SERVICE BULLETIN M20-282-A

Revised Date: September 22, 2004

SUBJECT: INSPECTION OF AVIONICS PRODUCTS, EATON, MOONEY OR VICKERS LANDING GEAR ACTUATORS [MAC P/N'S – 560254-501, -503, -505, AND –507; AVIONICS PRODUCTS AND EATON (OR VICKERS) P/N'S 102000-1, -2, -3, -4, -5, -7]
Revision A corrected return address for actuators to be reworked.

Document No.	SI102000-1-901 Rev. 2
Subject:	Landing Gear Actuator No-Back Inspection
Date:	April 3, 2003

FIGURE SB M20-282-1

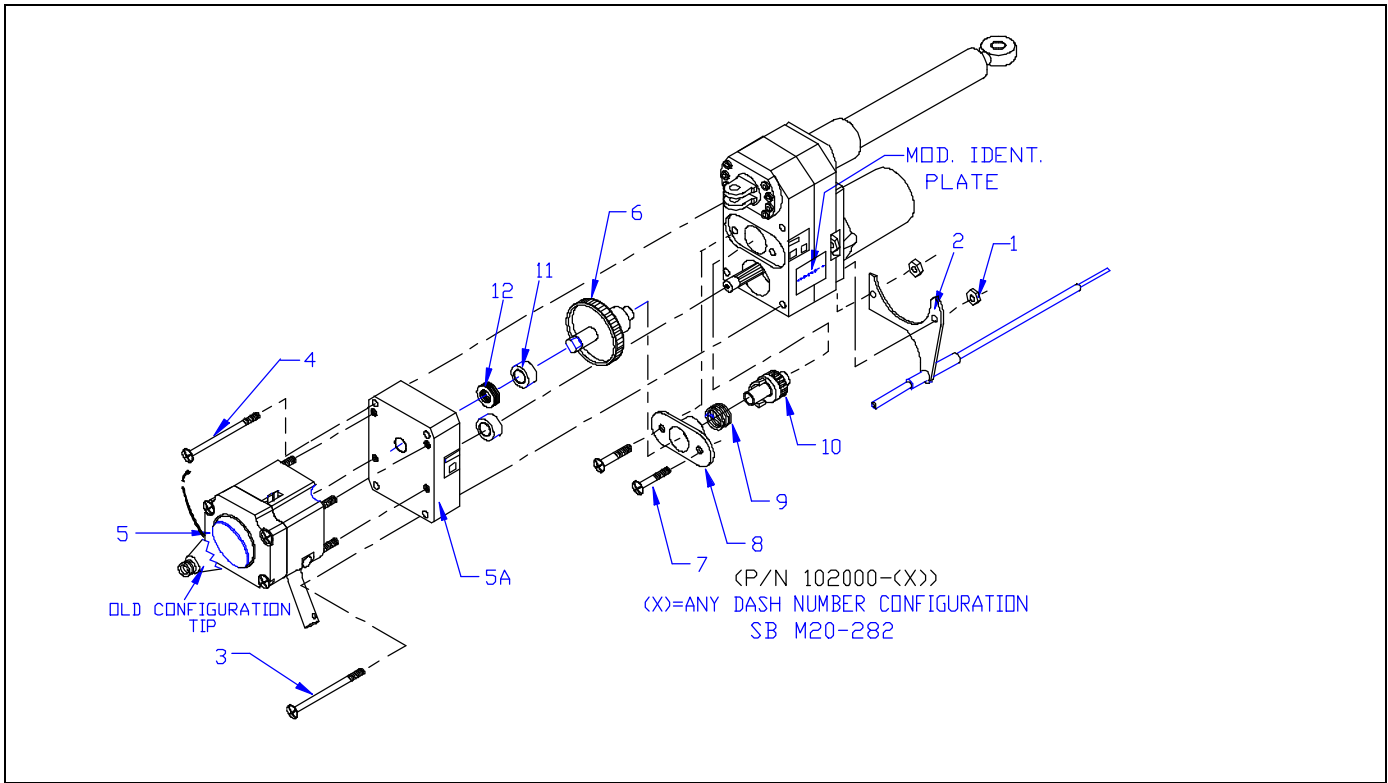
DISASSEMBLY OF ACTUATOR: [Reference **Figure SB M20-282-1**]

1. To avoid stripping screw heads, use impact screwdriver to break Loctite thread seals and remove two (2) long screws (Item 3) and two (2) short screws (4).
2. With razor or similar tool, slice through identification plate and remove recoiler assembly (5) and Clutch Housing Mount Assembly (5A).

3. Remove input gear assembly (6) from clutch housing (8) by pulling with slight force.
10. Remove two (2) screws (7) and remove clutch housing (8), "No-Back" Clutch Spring (9), and output gear assembly (10) from actuator body.
4. Remove "No-Back" Clutch Spring (9) from clutch housing using input gear assembly (6) as removal tool. Insert input gear assembly (6) into "No-Back" Clutch Spring from flanged end of housing (8). Remove "No-Back" Clutch Spring by rotating gear CCW and pulling slightly.

1. Lubricate clutch housing and new spring with lubricant supplied [MIL-G-81322].
2. Use gear assembly (6) as insertion tool; place new "No-Back" Clutch Spring on cam end of assembly and while rotating CCW, install "No-Back" Clutch Spring into clutch housing to about mid-point. **DO NOT FORCE SPRING**. While rotating CCW, gently push "No-Back" Clutch Spring into housing bore until fully seated.
3. Withdraw gear assembly (6).
4. Insert clutch gear assembly (10) into "No-Back" Clutch Spring and housing from cylindrical end of housing, insuring that "No-Back" Clutch Spring tangs fit into recesses in cam.

CAUTION: In some instances, the new "No-Back" Clutch Spring chatters during electrical extension or retraction cycle. Proper shimming of the "No-Back" Clutch Spring/housing assembly, (items #6, 7, 8, 9 & 10), and bearing (11) with shims (12) is necessary, according to Eaton personnel, to eliminate the chatter.

11. Install housing mount assembly (5A). Tighten housing screws. Check rotational torque of the no-back clutch drive with a modified socket & torque wrench. Rotational torque should be no greater than 4 inch pounds (per Eaton SI 102000-1-901, Rev. 2) in both CCW & CW directions. The objective is to remove endplay without applying a preload on the bearings. If rotational torque is greater than 4 inch pounds, remove housing mount (5A) and add or remove the least amount of shims (12) necessary to obtain proper rotational torque.

FIGURE SB M20-282-2

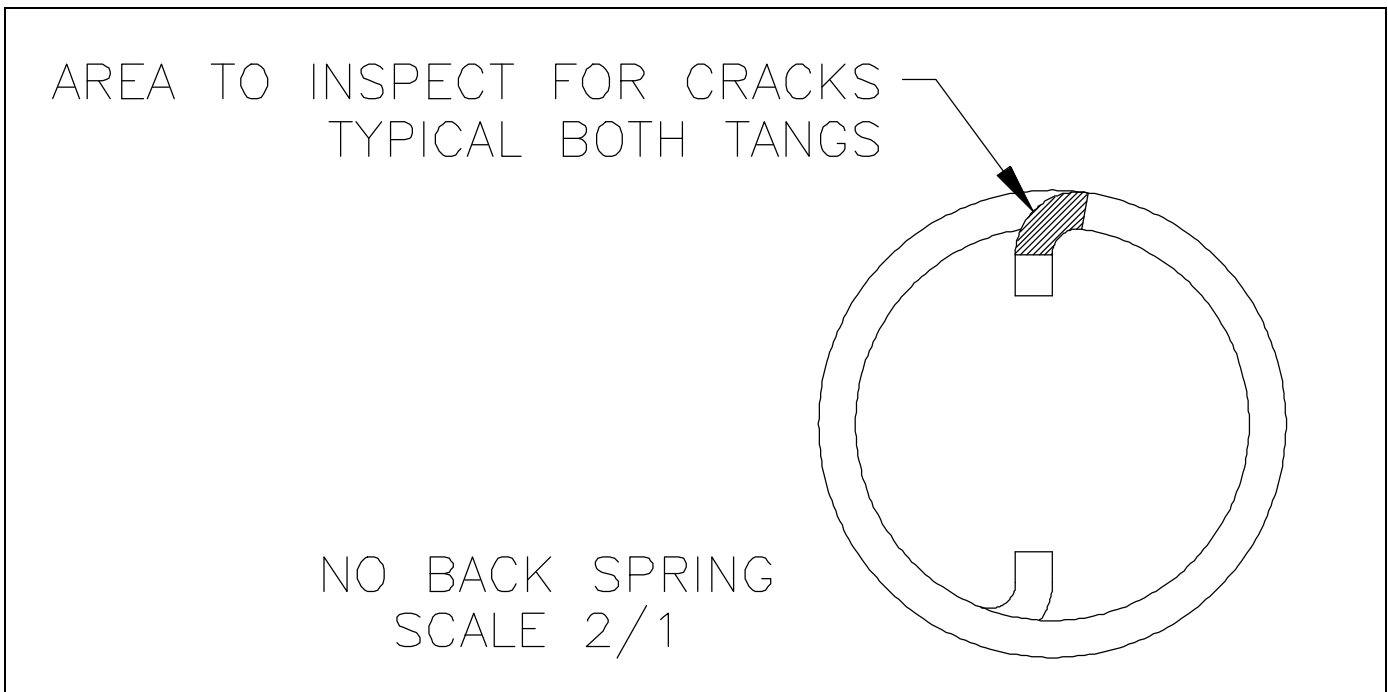
1. The inspection will require the use of a magnifying glass in the 16X to 40X power range. This inspection should be conducted in a clean room environment with good lighting.
2. If a maintenance shop has any "No Back" Clutch Springs in inventory, it is recommended that these also be visually inspected by qualified shop QA personnel in accordance with the criteria of Step 3 below and tagged as approved with a NOTE or Date Stamp documented by the maintenance shop QA personnel.
3. All clutch springs, either from the actuator or from shop inventory, must be visually inspected at the bend radius of both "tang ends" for evidence of any type of crack or stress fracture in the outboard, bend radius [reference **Figure SB M20-282-2** for additional inspection criteria]

4. If any evidence of a crack or stress is found, the clutch spring must be discarded.
5. An approved, new clutch spring that has been inspected and documented as inspected and approved either by a maintenance shop's QA personnel per Step 2 above or a clutch spring received from Mooney Airplane Company, Inc., which has been inspected by MAC Quality Inspection Department personnel are eligible for installation into the actuator removed from the aircraft.

Figure 1.

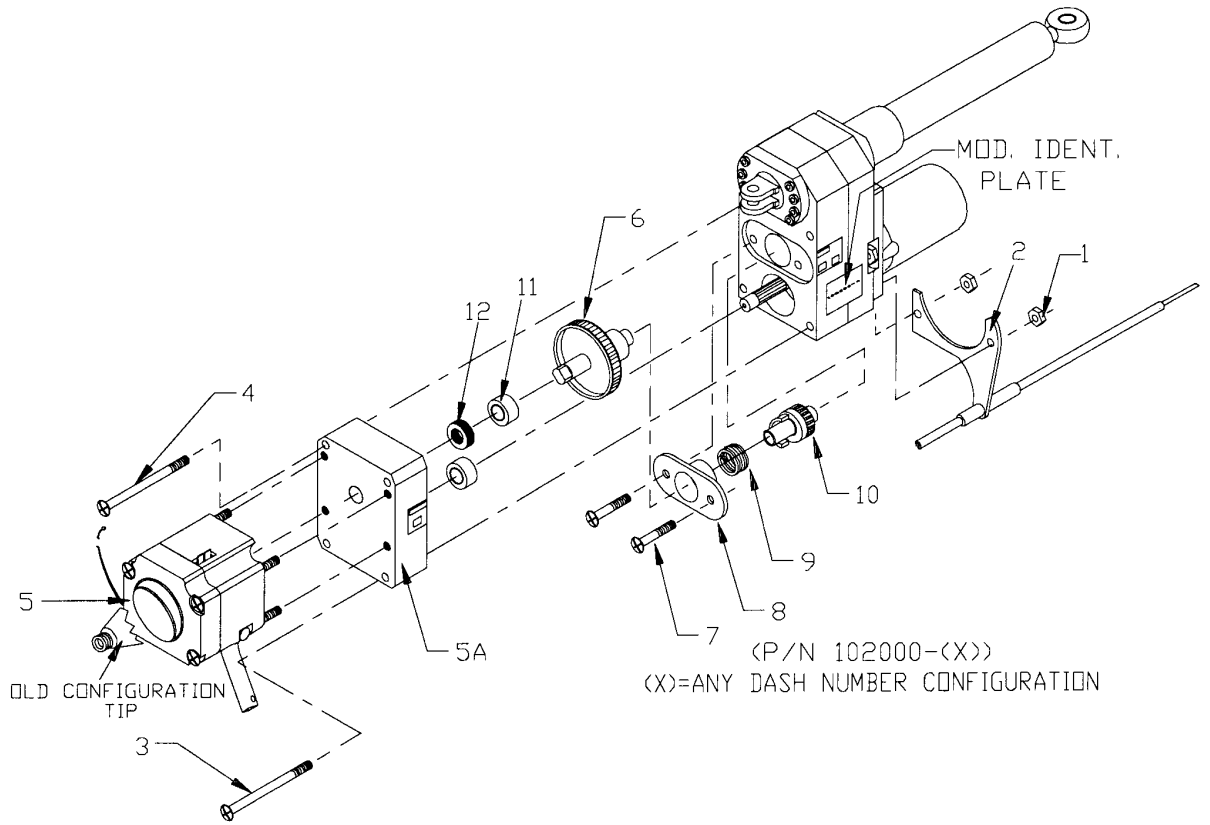
1. Remove the two long screws (item 3) and two short screws (item 4) securing the recoiler assembly to the actuator.
2. With the four screws removed, separate the recoiler assembly (item 5) and the no-back clutch housing mount (item 5A).

3. Remove input gear assembly (item 6) by pulling with slight force.
4. Remove two screws (item 7) securing the clutch housing (item 8), remove the clutch housing and no-back spring (item 9). Remove the output gear assembly (item 10).

11. Verify set screw alignment with index marks. Apply a thin film of MIL-G-81322 grease to the inside diameter of the no-back housing (item 8) and to the inside of the no-back spring (item 9). Apply a thin film of MIL-G-81322 grease to both gears, hubs and shafts.

14. Reinstall the two screws (item 7) securing the clutch housing (item 8) into the actuator body, use loctite on screw threads and tighten securely.
15. Insert the input gear and hub assembly (item 6) into the clutch housing and rotate to engage hub notches into clutch spring tangs. Verify that rotation of input gear both clockwise and counter clockwise results in movement of the jackscrew.

17. Install the housing mount assembly (item 5A) and tighten the housing screws. Check the rotational torque of the no-back clutch drive with a modified socket and torque wrench, rotational torque should be no greater than 4 inch pounds in both directions. The objective is to remove endplay without applying a preload on the bearings.

18. If rotational torque is greater than 4 inch pounds, remove housing mount(item 5A) and remove the least amount of shims (item 12) necessary to obtain proper rotational torque. Shims are installed under the bearing (item 11) within the housing mount assembly (item 5A). Three different thickness of shims are available, and any combination of these three are allowed to achieve proper rotational torque of the input gearshaft with the housing mount installed and torqued.

Figure 2.

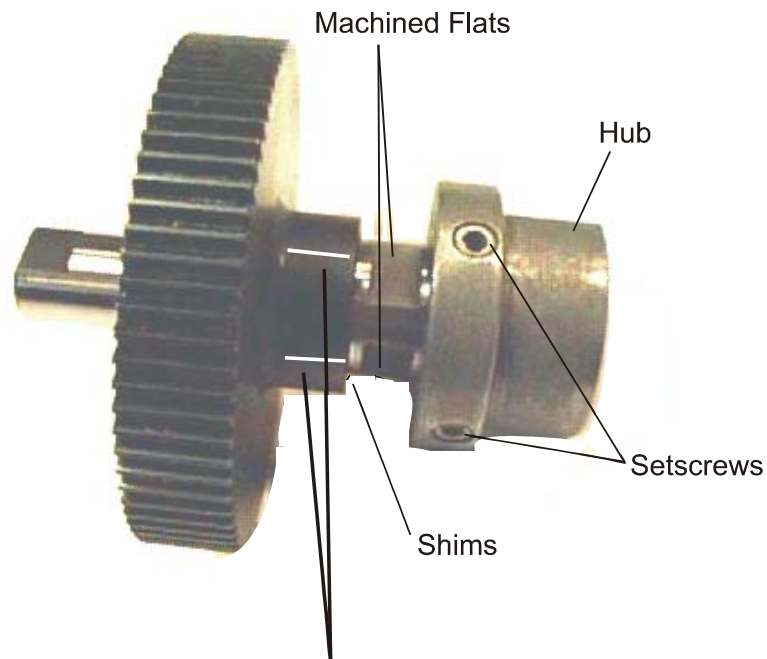
5. Remove input hub from input gear shaft by loosening the two set screws. Note the location and quantity of shims and reinstall upon reassembly.
6. Clean and inspect the parts, Replace any parts with damage.
7. Index mark the location of the two machined flats of the gear shaft onto the shaft shoulder next to the gear by applying a small dot of paint, refer to figure 2.

Scribe Alignment Marks To Indicate Position of Both Machined Flats of Input & Output Gears in relation to Setscrews

8. Wash all no-back clutch parts in acetone prior to reassembly. An oil free surface must exist for the proper adhesion of the loctite product.
9. Reinstall shims (as removed) onto input gear shaft and apply a liberal coating of loctite 609 to the gear shaft area of hub contact. Reinstall hub aligning the set screw holes with the index marks. Ensure the hub is seated firmly against the shims and gear shaft shoulder. Apply loctite 609 to set screws and reinstall, tighten set screws ensuring that they are fully seated on the gear shaft flats. Torque Set screws to 5 to 8 inch pounds.
10. Repeat steps 8 through 9 for the no back clutch output gear.
